**Subject: Proposed Official Plan and Zoning By-law Amendment, Draft Plan of Subdivision  
Triple Crown Line Developments Inc.  
Location: 15717 & 15505 Airport Road and 0 Innis Lake Road  
Town of Caledon Files: POPA 17-01, RZ 17-06, 21T-17004  
Region of Peel Files: OZ-17-001C, 21T-17004C**

**Re: URBAN DESIGN REVIEW  
Proposed Draft Plan of Subdivision, Zoning By-law Amendment & OPA  
Triple Crown Line Developments Inc. (McLeod)  
15717 and 15505 Airport Road, 0 Innis Lake Road, Caledon East  
Part Lots 18, 19 and 20, Concession 1 (ALB)  
File No's: 21T-17004C, RZ 17-06, POPA 17-01  
Our Ref No.: W-2120**

FIGURE 19 - Priority Lot Plan

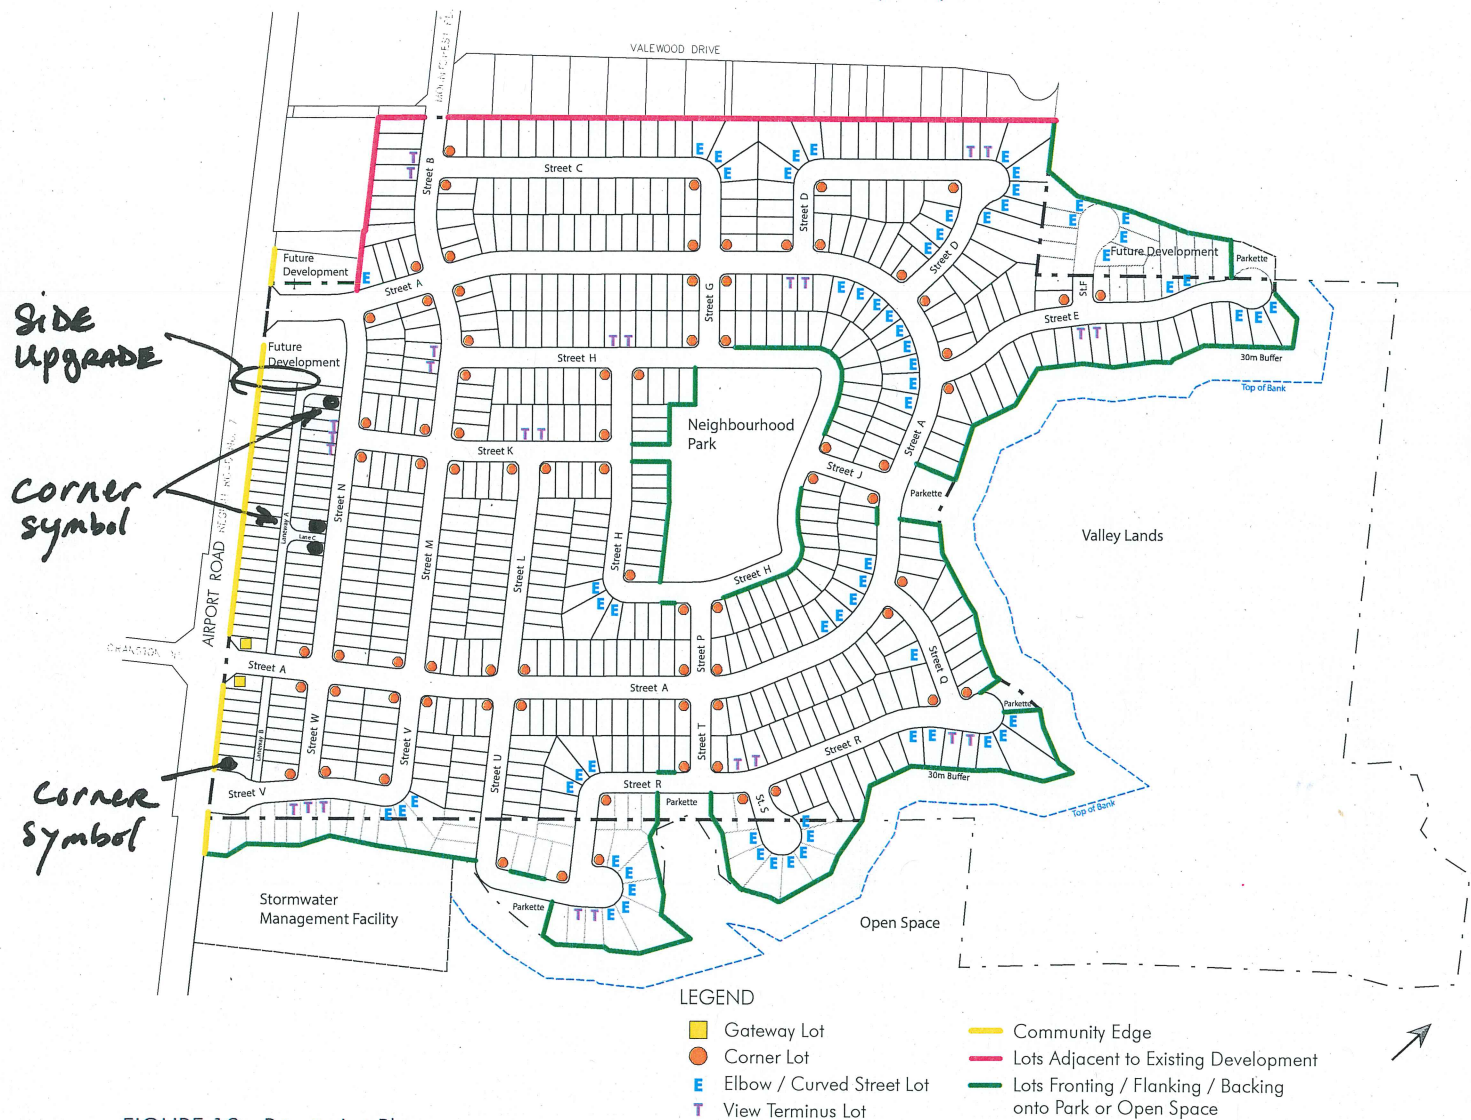
- c. We have noted some minor adjustments to the Priority Lot Plan and the Fencing Plan (see attached).
  15. It is recommended that the applicant provide Supplementary Community and Architectural Design Guidelines that are specific to the Triple Crown Line neighbourhood and which expand upon the built form principles of the Urban Design Brief. It is our opinion that the Caledon East Community Design and Architectural Design Guidelines (2000) are outdated and do not contain sufficiently detailed and current architectural / siting design criteria to ensure the goals of the Town are met with respect to high quality built form.
